SUBJECT: NuScale Power, LLC Response to NRC Request for Additional Information No. 420 (eRAI No. 9459) on the NuScale Design Certification Application

NuScale Response to NRC Request for Additional Information eRAI No. 9459

NRC Question No.: 03.08.02-18

Figure 3-4 Reinforcement Added to PZR Access Opening

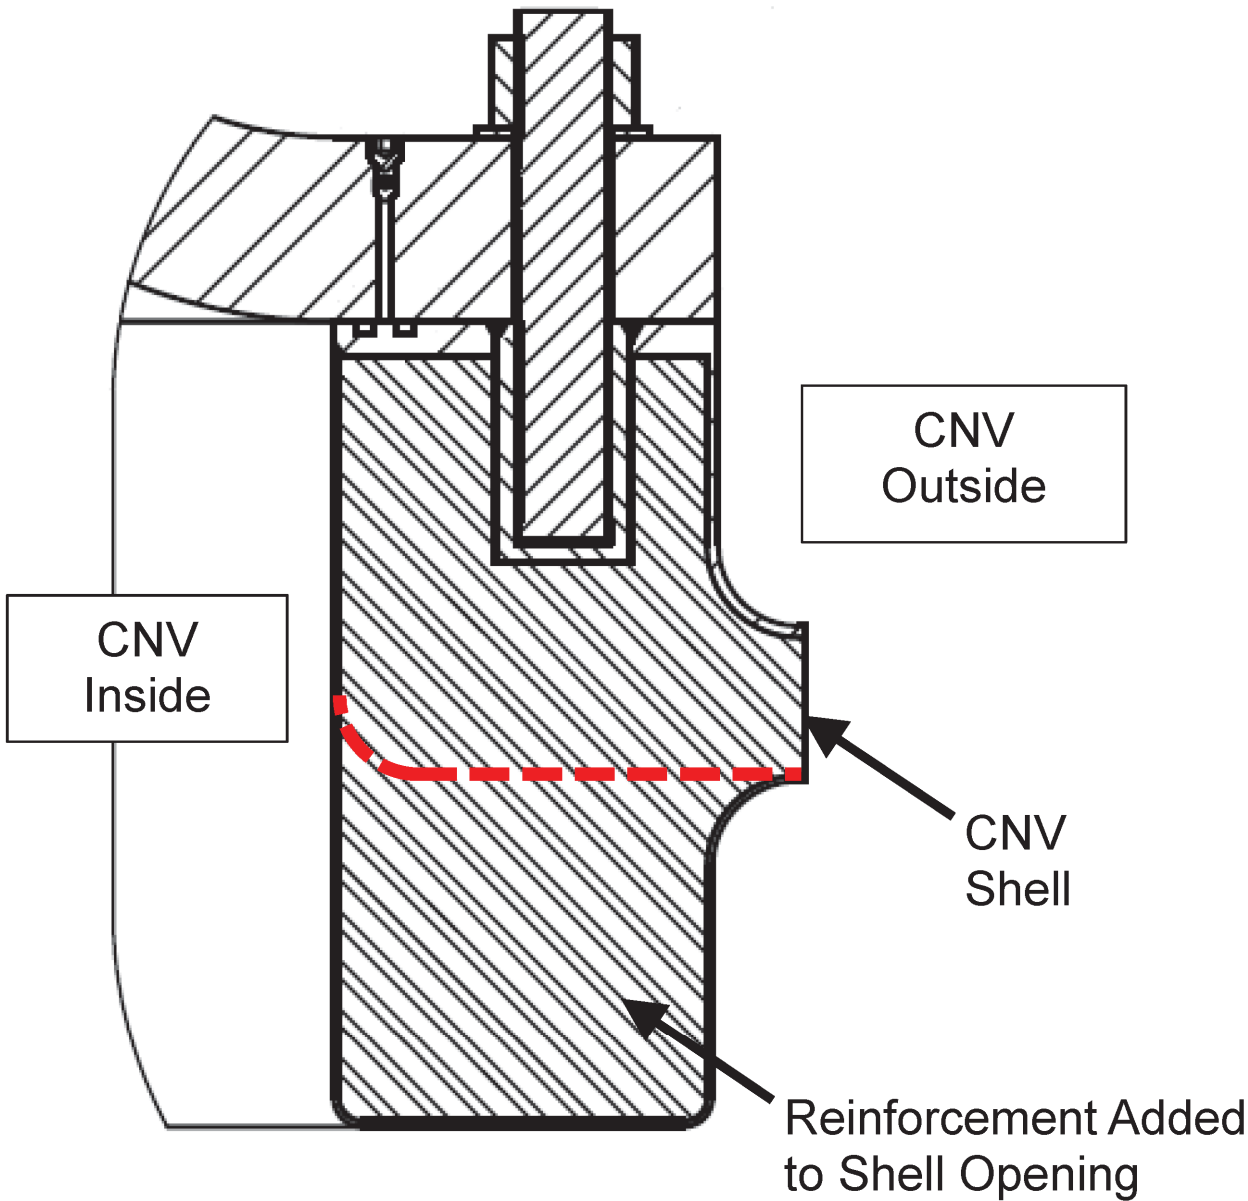
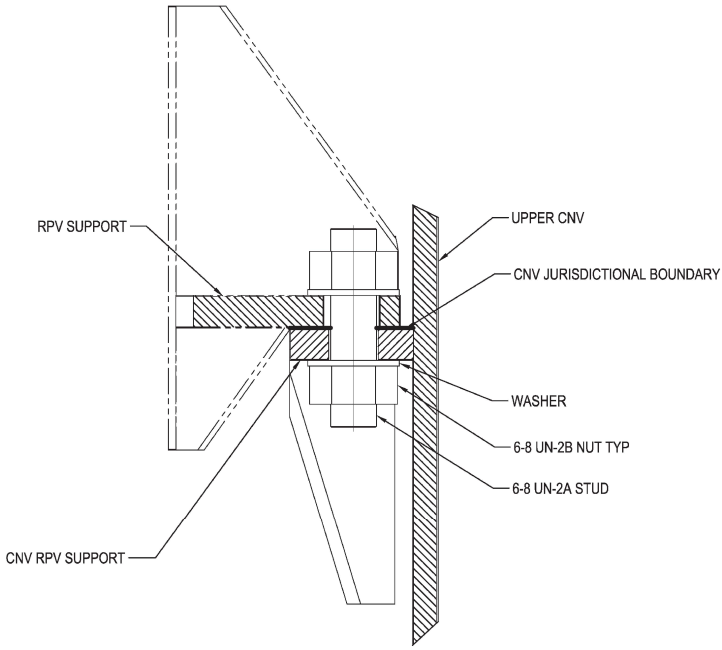
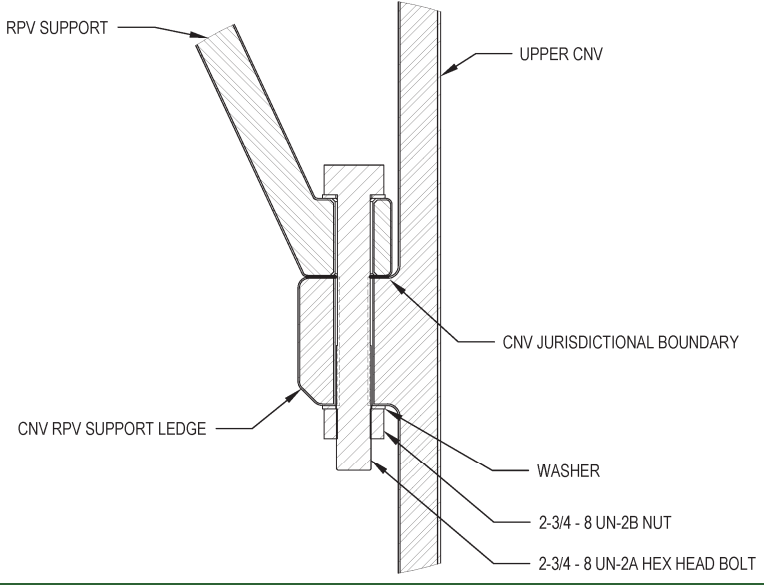
For the CNV Middle Section Model, in Section 3.4 of TR-0917-56119-P, "CNV Ultimate Pressure Integrity," it states that the design was modified to add 7.5 inches of reinforcement around the pressurizer access port opening on the inside surface of the CNV. The report stated that the added reinforcement served to stiffen the CNV shell around the opening and produce less distortion of the access flange, however the addition of the 7.5 inches of reinforcement is not clearly indicated in the drawings of the technical report, nor are there any further details on the reinforcement and its effect on the analysis. Please clearly show the reinforcement on the drawings of the technical report.

It does not appear that the analysis of the CNV Middle Section was re-evaluated to include this 7.5 inches of reinforcement. Please explain why this analysis was not re-evaluated as the reinforcement could produce a different bounding ultimate pressure than is currently indicated in the FSAR.

Figure 3-4 was added to TR-0917-56119, CNV Ultimate Pressure Integrity Technical Report, Section 3, showing the reinforcement around the pressurizer (PZR) access port flanged

opening. The discussion provided in Section 3.4, under Containment Vessel (CNV) Pressure Capacity Models, Item 2, CNV Middle Section Model, was modified to better describe the reinforcement around the pressurizer access opening and to reference the new Figure 3-4.

... The added reinforcement serves to stiffen the CNV shell around the opening and produce less distortion of the access flange. This additional reinforcement produces a smaller and more uniform deflection of the flange. More deflection of the cover due to a higher pressure is therefore needed to reach the failure criteria specified in Section 3.1. Therefore, the resultant calculated CNV ultimate pressure produces a lower, bounding ultimate pressure from that expected with the added reinforcement.

Because a lower ultimate pressure is more limiting than a higher pressure, the current TR ultimate pressure bounds the increased ultimate pressure with the added reinforcement. Accordingly, the current design with added reinforcement was not re-analyzed.

After the analysis of the CNV ultimate pressure was performed the design was modified to add 7.5 inches of reinforcement around the pressurizer access port opening on the inside surface of the CNV at the vertical top and bottom positions of the opening and transitioning to about 2.1 inches of reinforcement on the horizontal left and right positions of the opening. The location of the additional reinforcement added to the pressurizer access port opening is shown in Figure 3-43 below, but is not included in the CNV Ultimate Pressure Capacity middle section model. The added reinforcement serves to stiffen the CNV shell around the opening and produce less distortion of the access flange. This additional reinforcement produces a smaller and more uniform deflection of the flange. More deflection of the

Figure 3-7 RPV Lateral Support Geometry

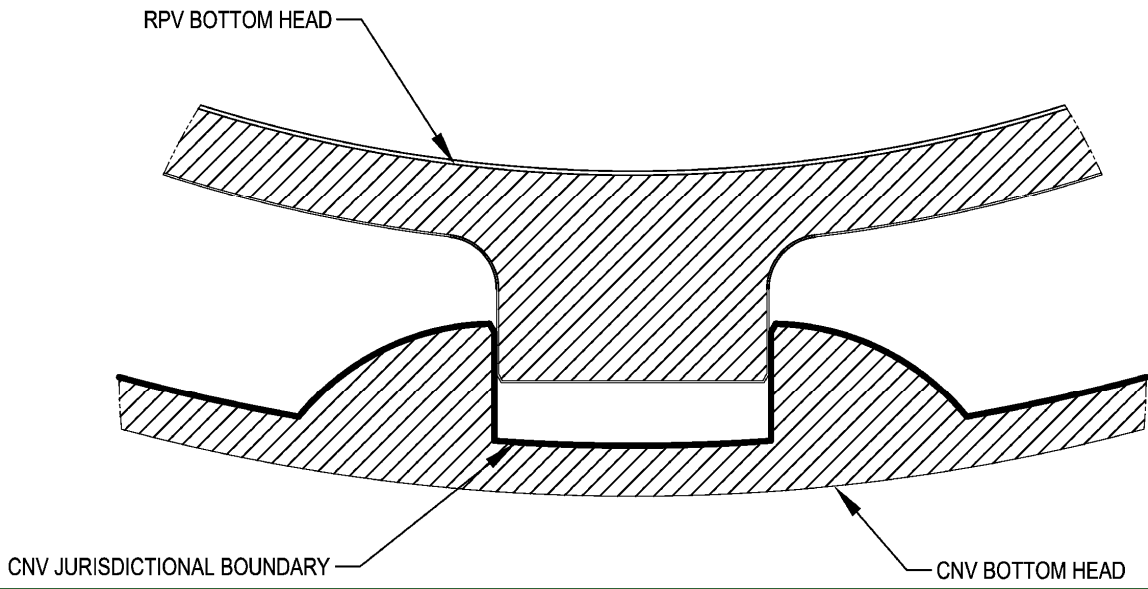
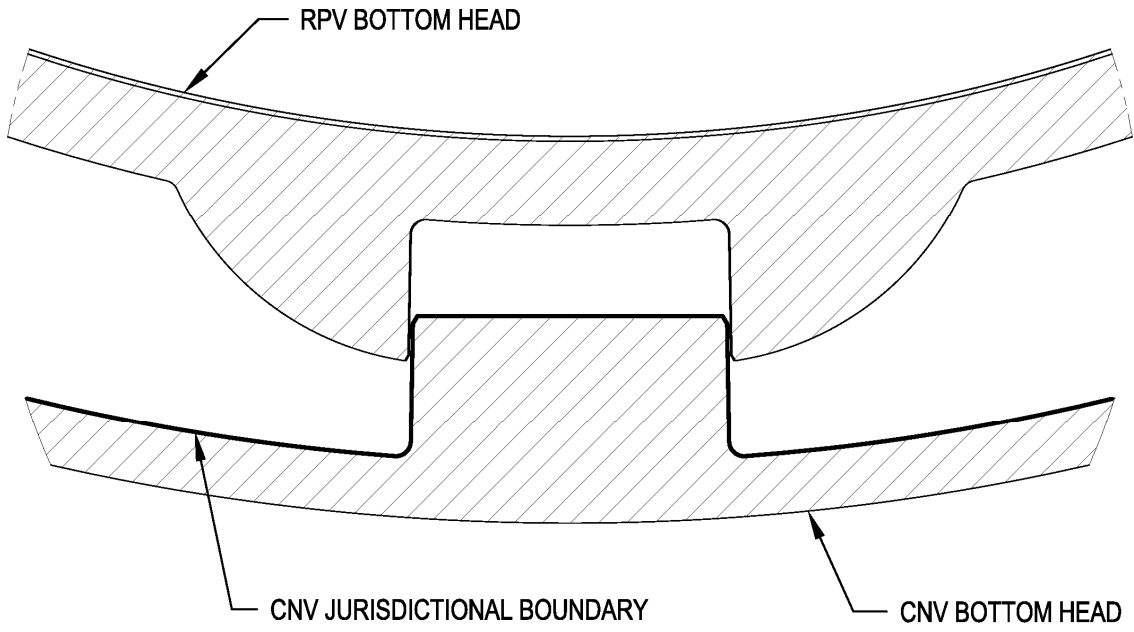
The RPV support design and RPV lateral support design, which impart stress to the shell of the containment vessel, were both modified since the completion of the containment ultimate pressure analysis. Please include drawings within the technical report that clearly show the differences in design from the one used for the ultimate pressure analysis (for example Figure 3-3) and the current design, to support the statements made that these design changes do not affect the ultimate pressure capacity or buckling results.

Figure 3-7(a) was added to TR-0917-56119, Section 3, to show the current RPV lateral support design and Figure 3-7(b) was added to show the RPV lateral support design analyzed. The discussion provided in Section 3.4, CNV Pressure Capacity Models, Item 5, Bottom Head Buckling Model, was revised to reference the new figures.

- The design of the reactor pressure vessel (RPV) lateral support located on the dome of the bottom head has subsequently been revised. The pin and retainer modeled in the analysis had the pin located on the bottom, inside surface of the CNV, and the retainer on the bottom, outside surface of the RPV. After completion of the analysis the design was modified to the ~~current~~DCA submitted design with the pin located on the RPV and the retainer on the CNV. Figure 3-7(a) shows the DCA submitted design of the RPV lateral support and Figure 3-7(b) shows the RPV lateral support design modeled for the analysis. Since the RPV lateral support is located at the center of the dome and remote from the knuckle, it provides no additional support to the knuckle. Therefore, this design change has no impact on the buckling of the knuckle due to internal pressure.
